FPL Energy
Seabrook Station

Docket No. 50-443
SBK-L-04044

Seabrook Station
Facility Operating License NPF-86
Changes to License Amendment Request 04-03,
Application for Stretch Power Uprate

**LAR-04-03, SUBSECTION 6.3.6
REVISED FIGURES**

Figure 6.3.6.1-1
Inadvertent Emergency Core Cooling Systems Operation
During Power Operation
Nuclear Power and Vessel Average Temperature versus Time

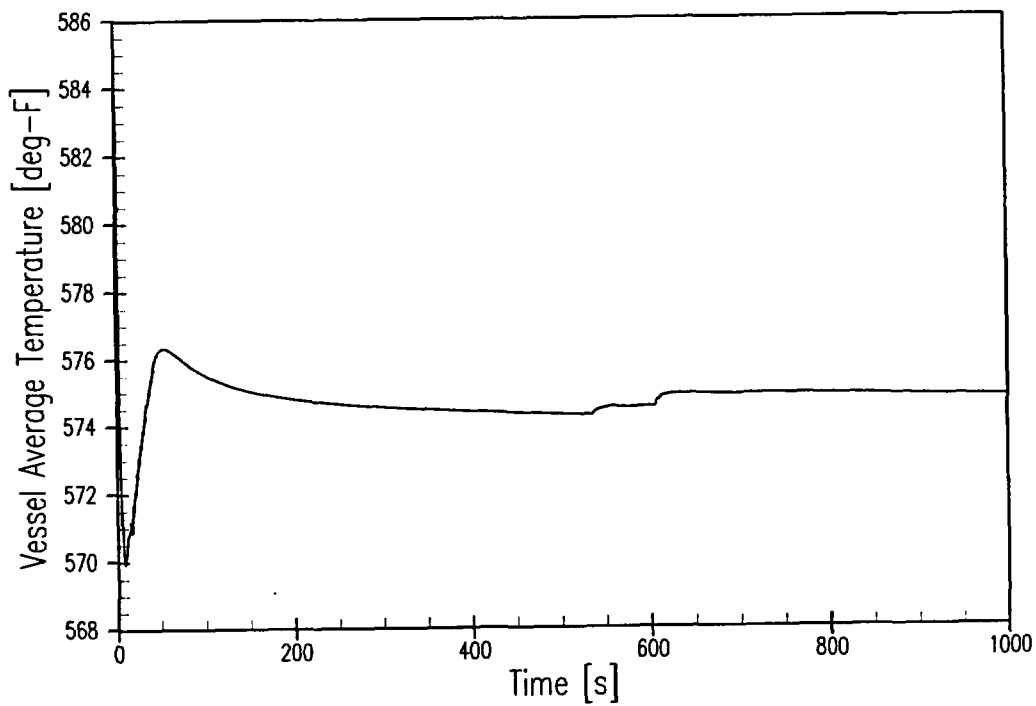
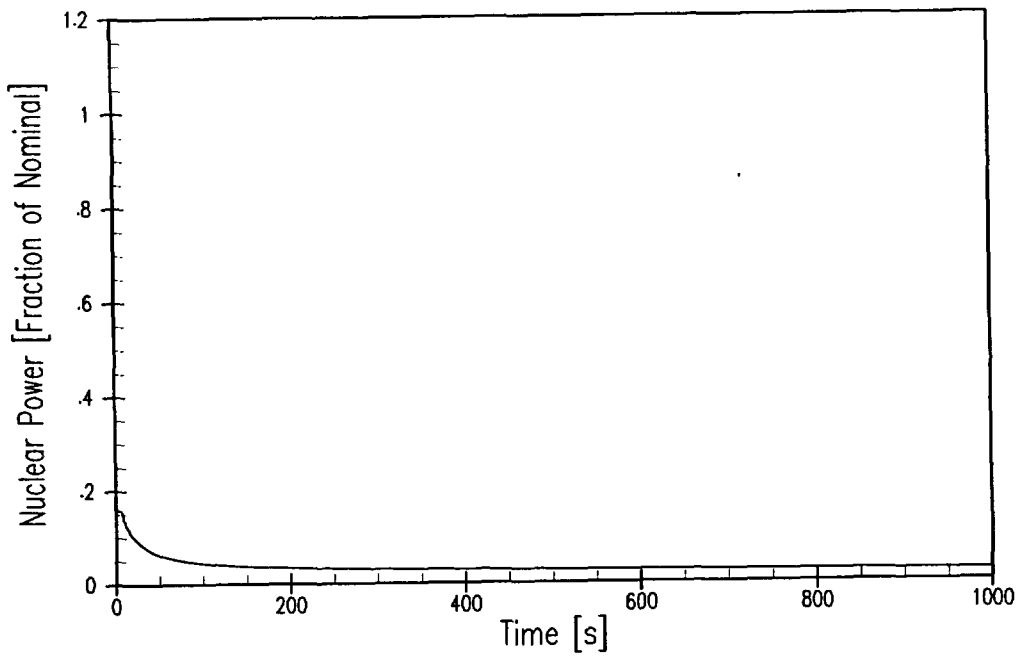
- LAR Attachment 1 Subsection 6.3.6, Increase In Reactor Coolant Inventory
 - LAR Subsections 6.3.6.1.2, 6.3.6.1.3, and 6.3.6.1.4, (pages 6-235 and 6-236) – The operator action time in the last paragraph of each subsection is revised from 10 minutes to 10.1 minutes.

- LAR Table 6.3.6.1-1 (page 6-239) - the Time entries for both the “Operator Stops Safety Injection” and “Maximum Pressurizer Pressure” are revised to 606.01 seconds and the Maximum Pressurizer Pressure reached is being revised from 2378.18 psia to 2386.19 psia.

- LAR Figures 6.3.6.1-1, 6.3.6.1-2, and 6.3.6.1-3 (pages 6-241 – 6-243, respectively) are replaced with the figures contained in Enclosure 3 to this letter.
